RESIDENTIAL DEVELOPMENT

8 Forest Road | Warriewood NSW 2102

SECTION 4.56(4) APPLICATION

SECTION 4.56 CHANGE LIST ADDENDUM (07/05/2024)

Drawing Title:
Elevations
Building C and D

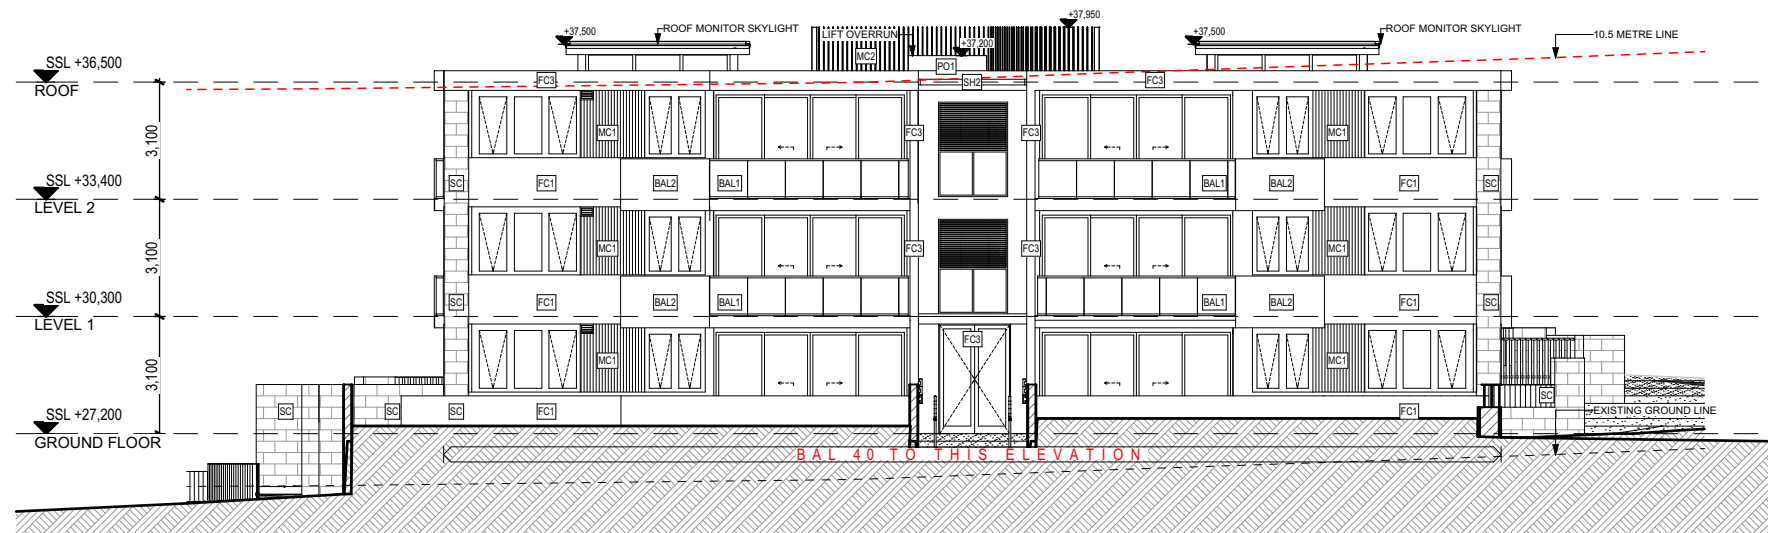
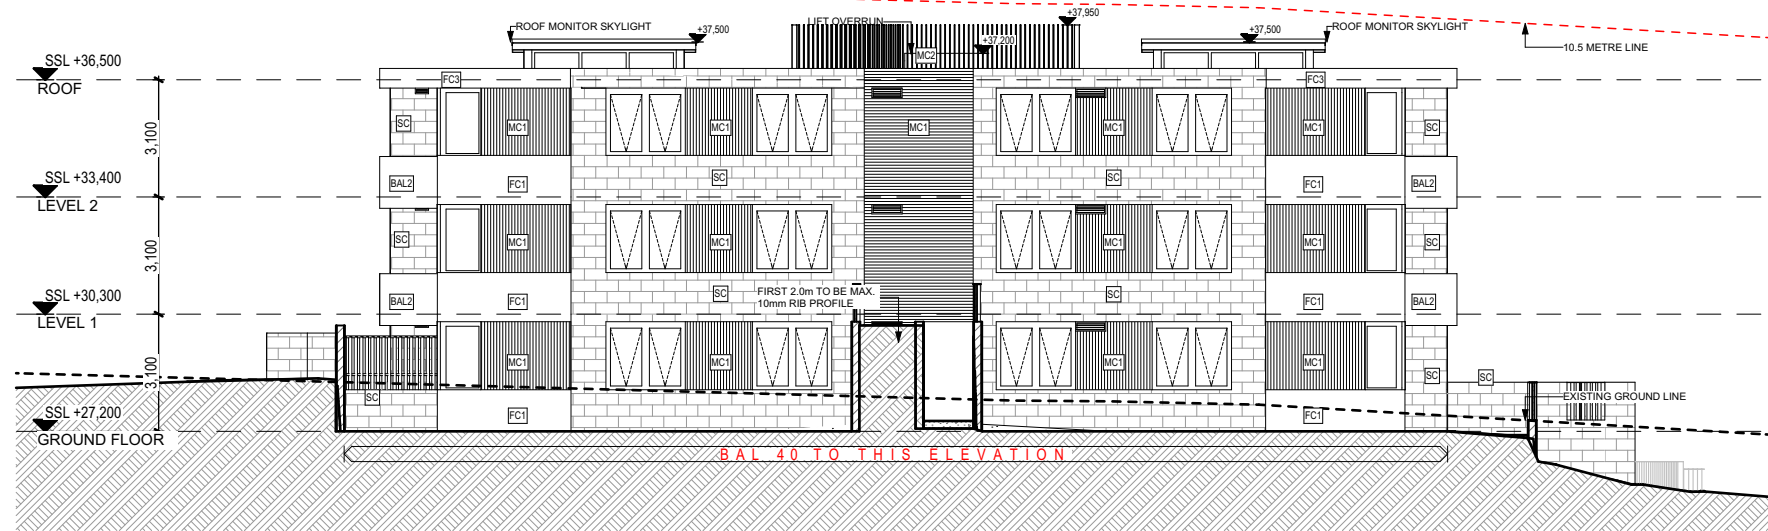
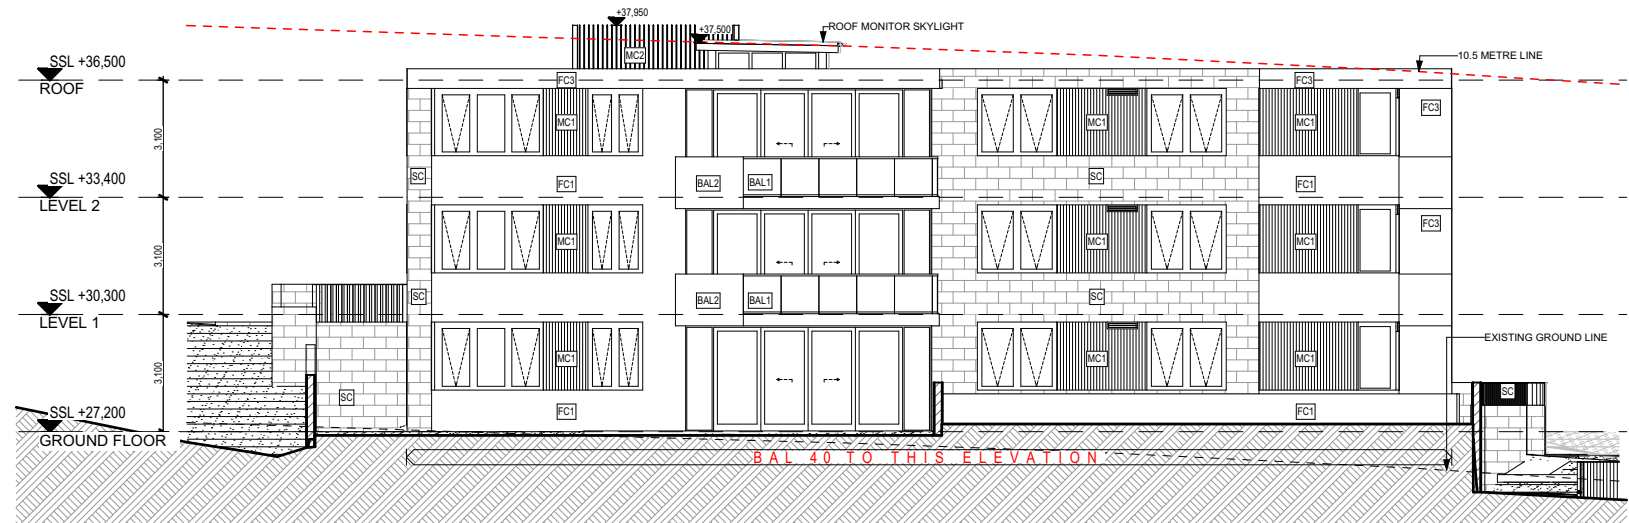
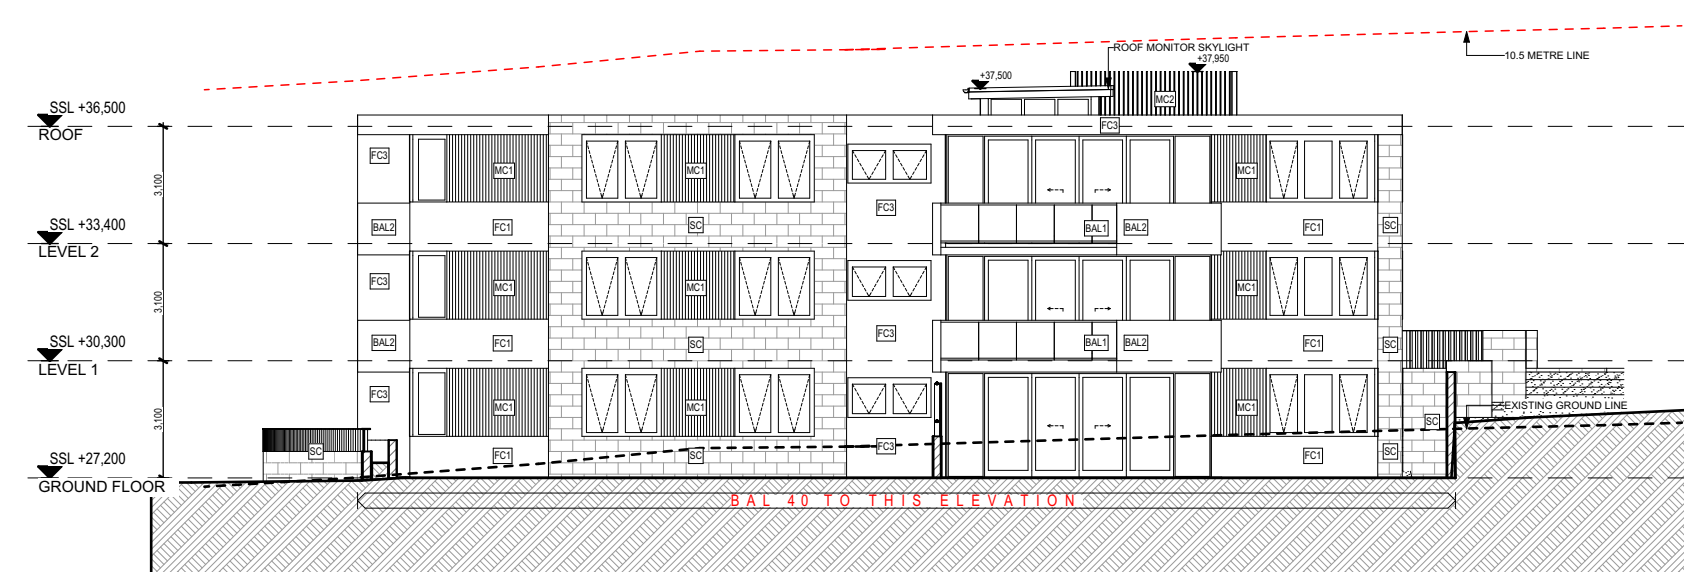
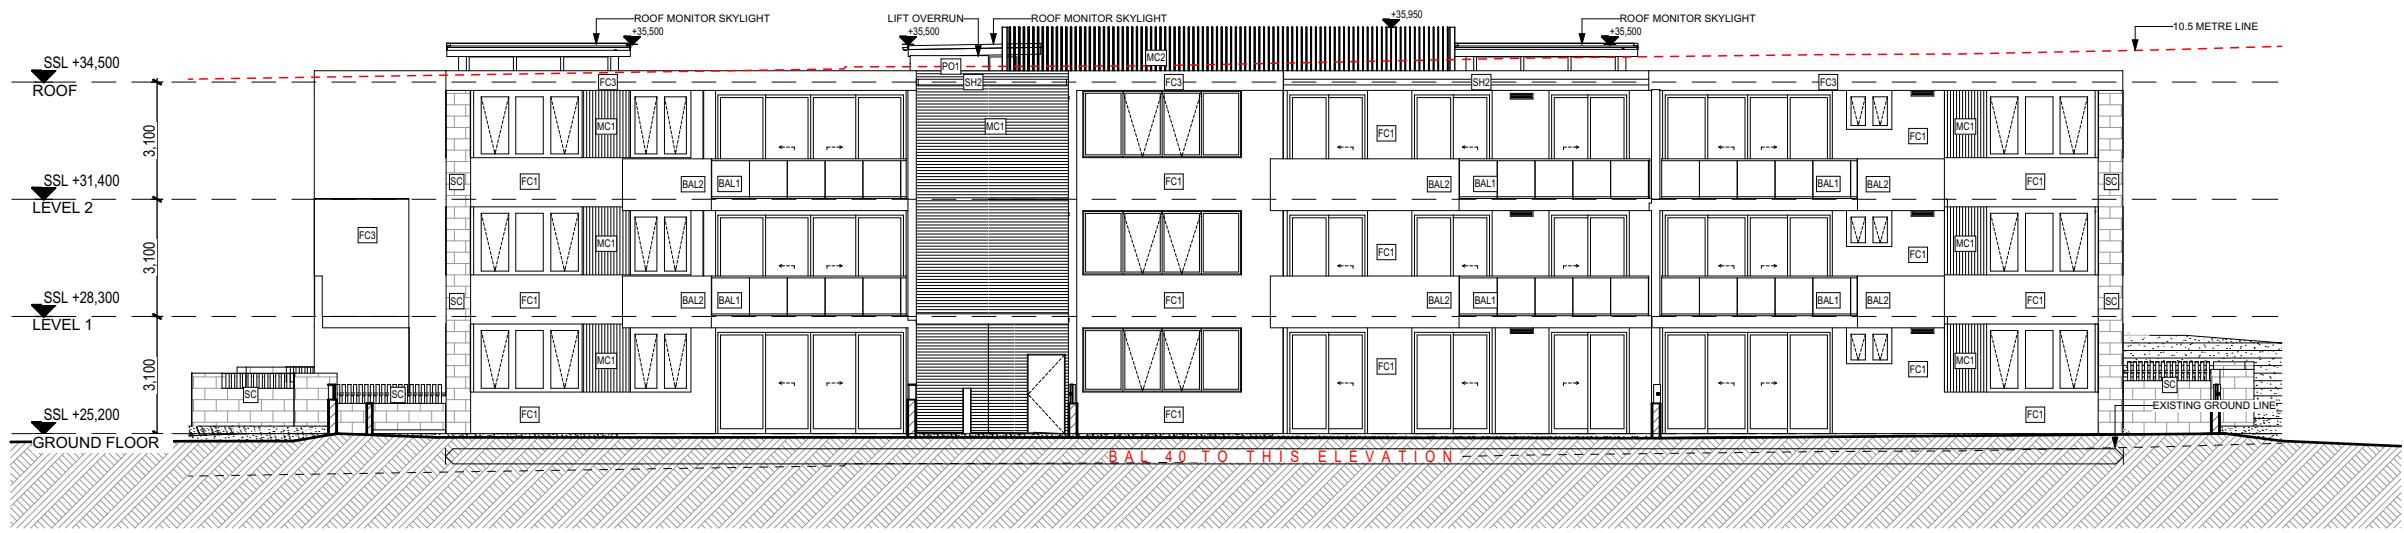
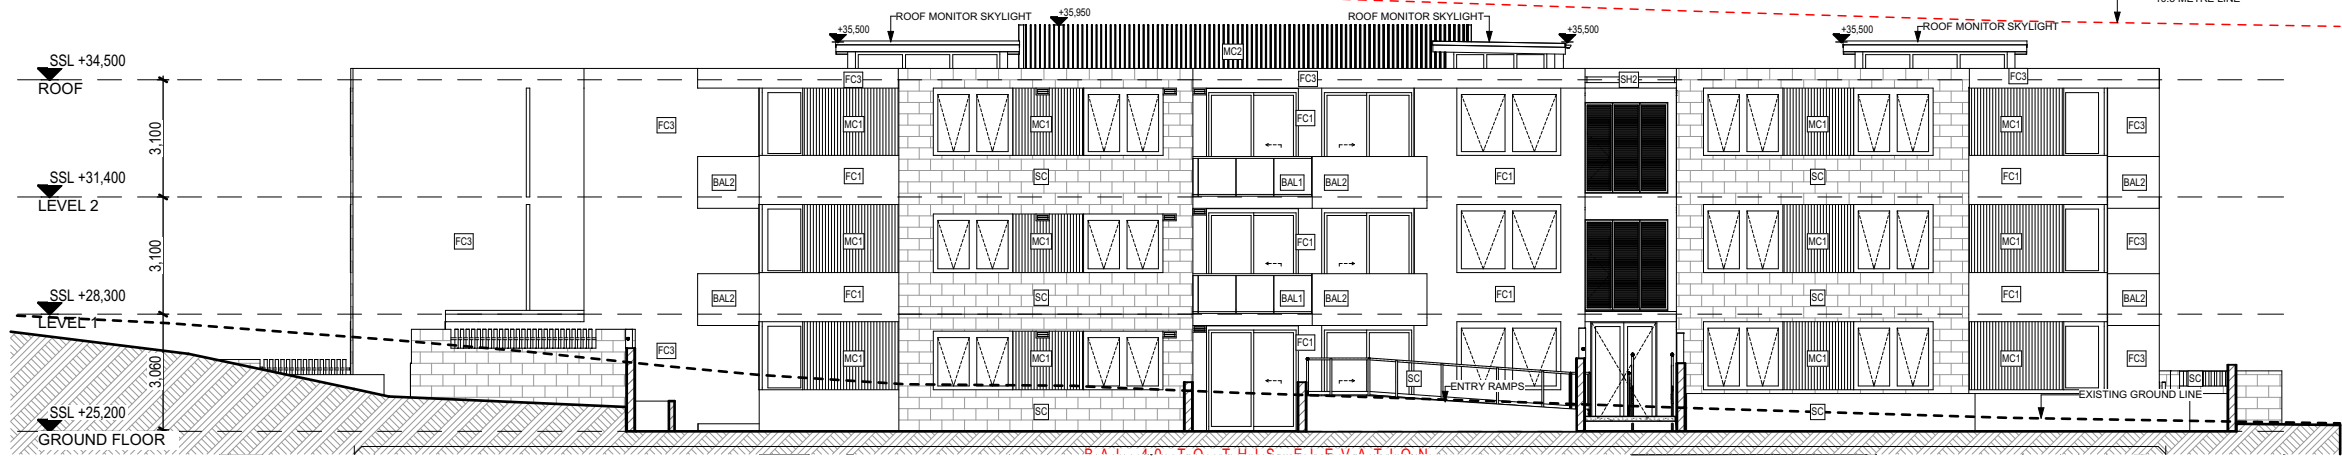
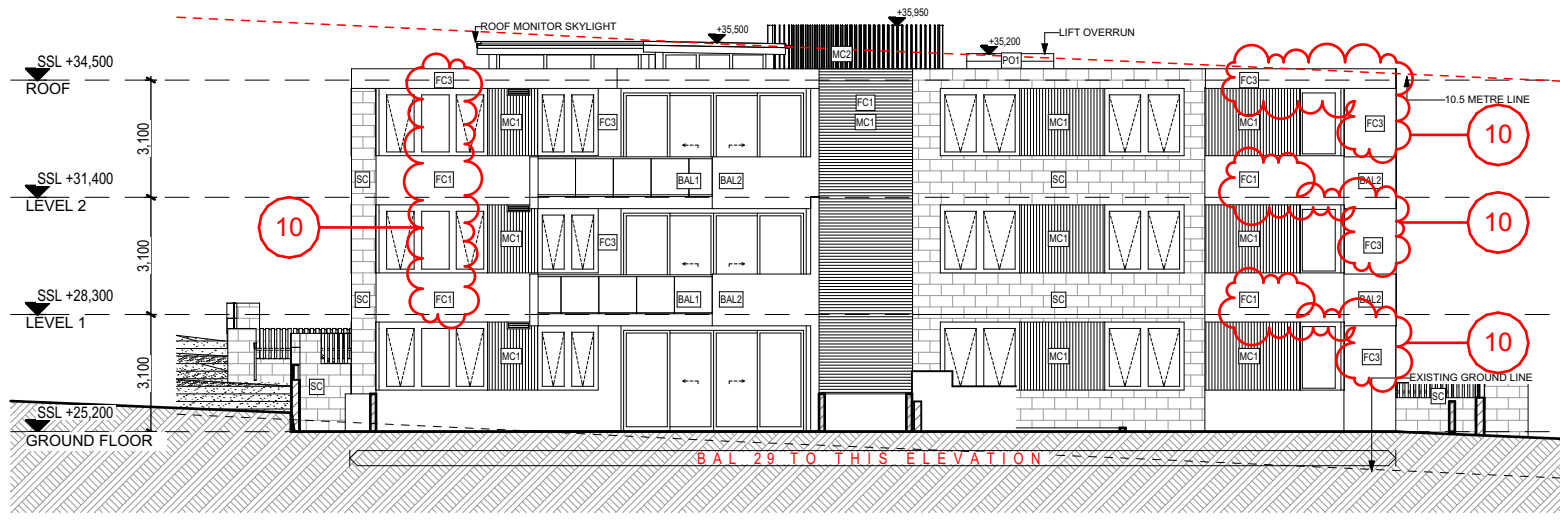
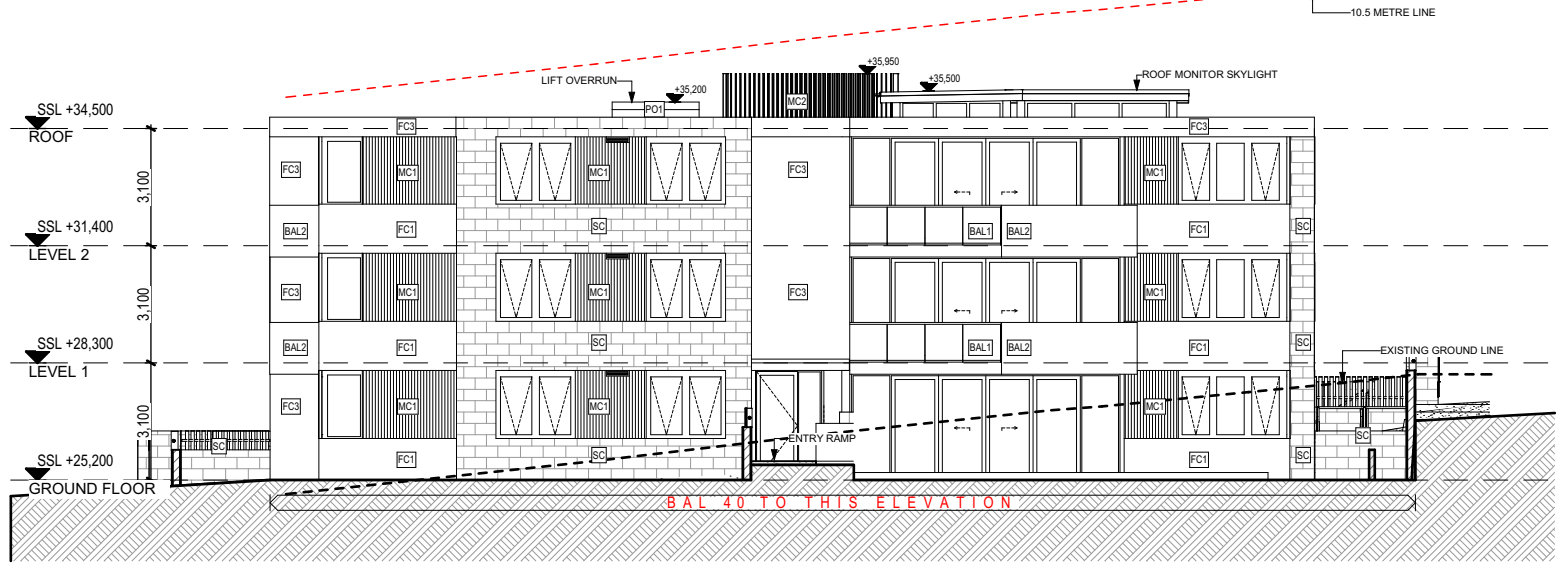
- INTERNAL FITOUT CHANGE INTO LIFT SPACE
 - LIFTS REMOVED FROM TOWNHOUSES 02, 03, 04, 05, 08, 09, 10, 11, 12, 13 & 14.
 - FINISH CHANGES, "TIMBER LOOK" CHANGED TO "DULUX DURALLOY ANOTEC MID BRONZE MATT" AND "SANDSTONE CLADDING" CHANGED TO "SANDSTONE LOOK"

- FACADE FINISH DRAFTING ERROR CORRECTIONS
 - LIFT OVERRUN REMOVED & ALLOWANCE FOR ROOF PARAPET ADDED, THE HEIGHT OF WHICH IS 100mm LOWER THAN THE PREVIOUSLY APPROVED LIFT OVERRUN HEIGHT.

Drawing Title:
Elevations
Townhouses

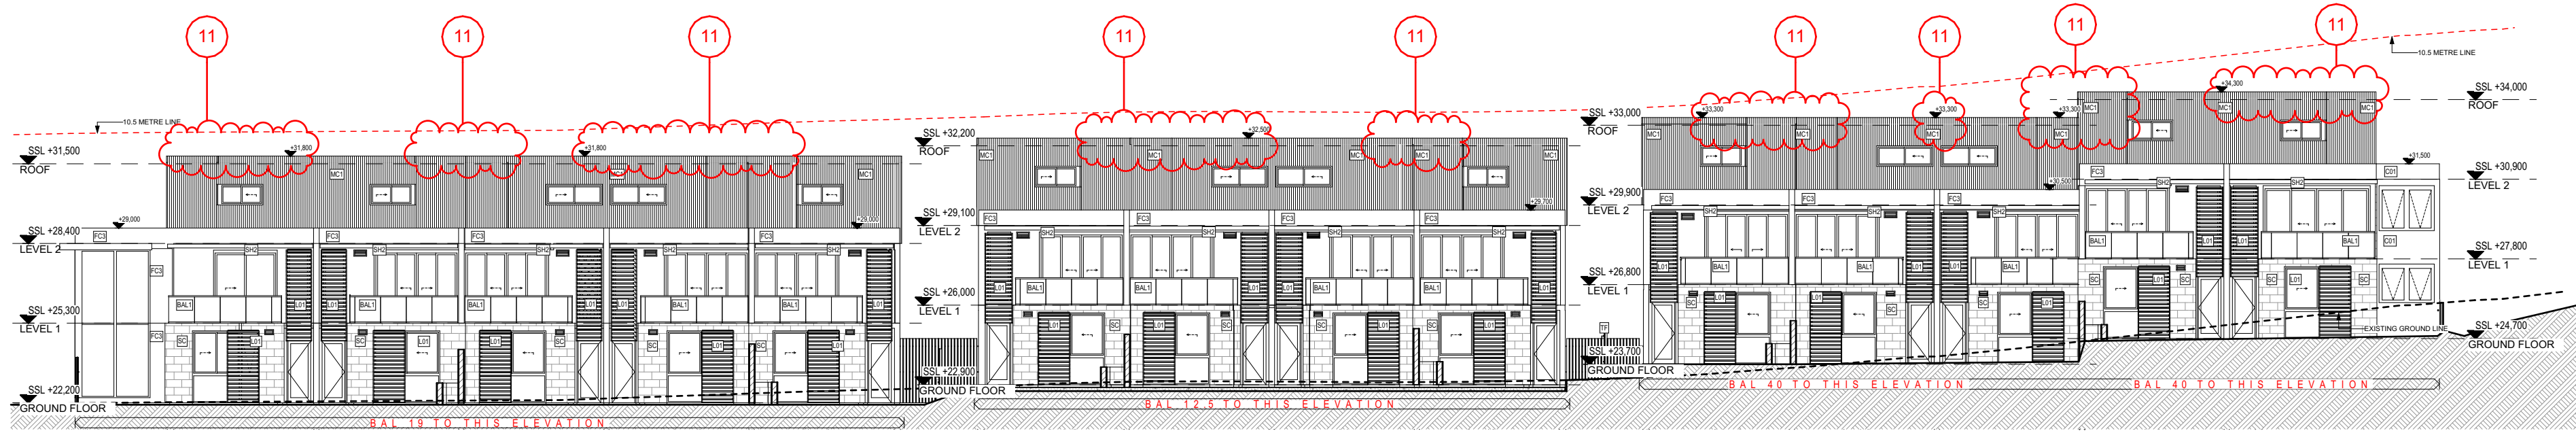
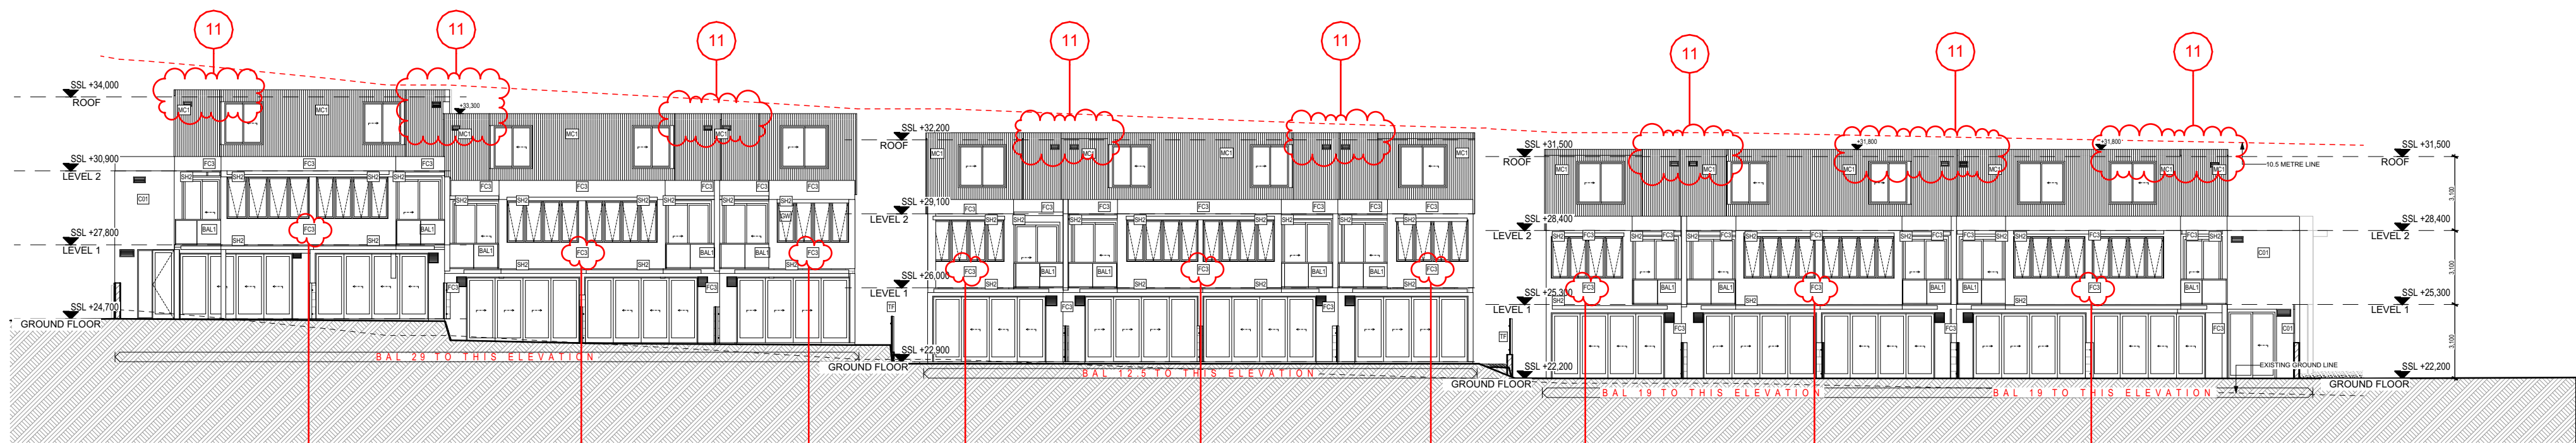
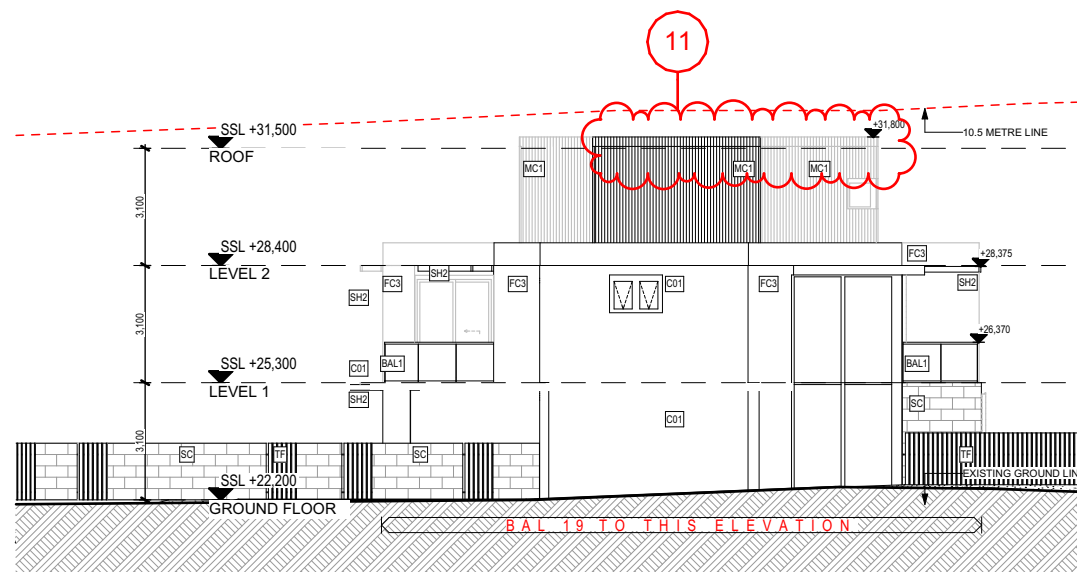
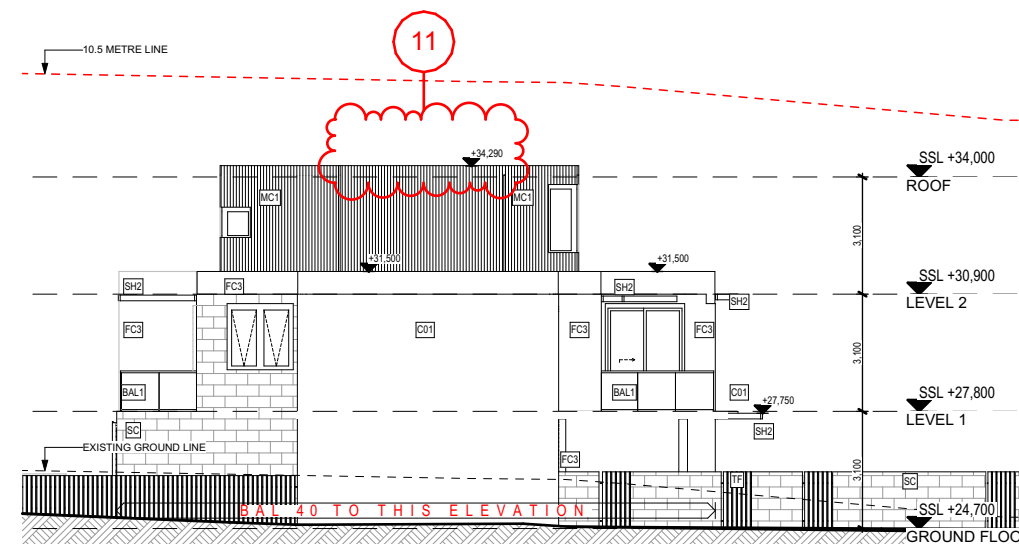
- INTERNAL FITOUT CHANGE INTO LIFT SPACE
 - LIFTS REMOVED FROM TOWNHOUSES 02, 03, 04, 05, 08, 09, 10, 11, 12, 13 & 14.
 - FINISH CHANGES, "TIMBER LOOK" CHANGED TO "DULUX DURALLOY ANOTEC MID BRONZE MATT" AND "SANDSTONE CLADDING" CHANGED TO "SANDSTONE LOOK"

- FACADE FINISH DRAFTING ERROR CORRECTIONS
 - LIFT OVERRUN REMOVED & ALLOWANCE FOR ROOF PARAPET ADDED, THE HEIGHT OF WHICH IS 100mm LOWER THAN THE PREVIOUSLY APPROVED LIFT OVERRUN HEIGHT.
